Item Name: Crosstube Assembly, Mid Fwd

DART AEROSPACE LTD	Work Order:	161181
Description: Crosstube Assembly, Mid Fwd	Part Number:	D206-667-147
Inspection Dwg: D206-667-147 Rev: A		Page 1 of 2

DART AEROSPACE LTD HAWKESBURY, ONTARIO, CANADA	
DRAWING NO. D206-667-147	REV. A SHEET 1 OF 4
TITLE CROSSTUBE ASS'Y (206L MID FWD)	SCALE NTS
COPYRIGHT © 2010 BY DART AEROSPACE LTD THIS DOCUMENT IS PRIVATE AND CONFIDENTIAL AND IS SUPPLIED ON THE EXPRESS CONDITION THAT IT IS NOT TO BE USED FOR ANY PURPOSE OR COPIED OR COMMUNICATED TO ANY OTHER PERSON WITHOUT WRITTEN PERMISSION FROM DART AEROSPACE LTD.

DRAWING NO. D206-667-147	TITLE CROSSTUBE ASS'Y (206L MID FWD)	REV. A	DART AEROSPACE LTD ENGINEERING ORDER		D.E.O. NO. D206-667-147-A-1	SHEET NO. SHEET 1 OF 1	SCALE NTS
DRAWN <i>q</i>	CHECKED <i>AS</i>	MFG. APPR. <i>JB</i>	APPROVED <i>MD</i>		DE APPR. <i>MD</i>		
DATE 11.07.15	DATE 11.07.20	DATE 11.07.21	DATE 11.07.21		DATE 11.07.21

DETAIL P
BONDING STRAP INSTALLATION 2 PL

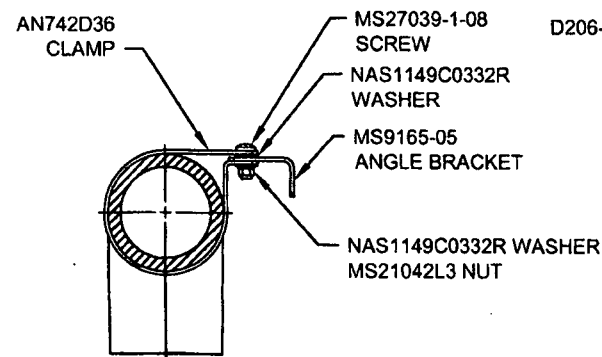
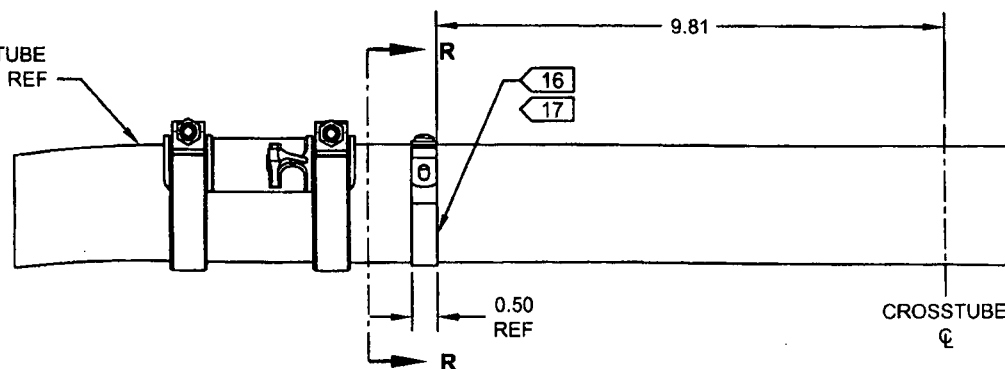
PURPOSE:

ADD ELECTRICAL GROUNDING STRAP

- 16) MASK AREA UNDER CLAMP PRIOR TO PAINTING
17) SEAL EDGES WHERE AN742D36 CLAMP MEETS WITH THE CROSSTUBE USING SIKAFLEX-241/-291 OR MIL-S-8802 CLASS B2 OR PROSEAL 890 SEALANT
18) PERFORM RESISTANCE CHECK TO ENSURE MAX RESISTANCE IS 10 MILLIOHMS

ITEM	QTY -147	PART NUMBER	DESCRIPTION
1	X	D206-667-147	CROSSTUBE ASSEMBLY (206L MID FWD)
10	2	AN742D36	CLAMP
11	2	MS9165-05	ANGLE BRACKET
12	2	MS21042L3	NUT (OR MS21042-3)
13	2	MS27039-1-08	SCREW
14	4	NAS1149C0332R	WASHER (OR AN960C10L)
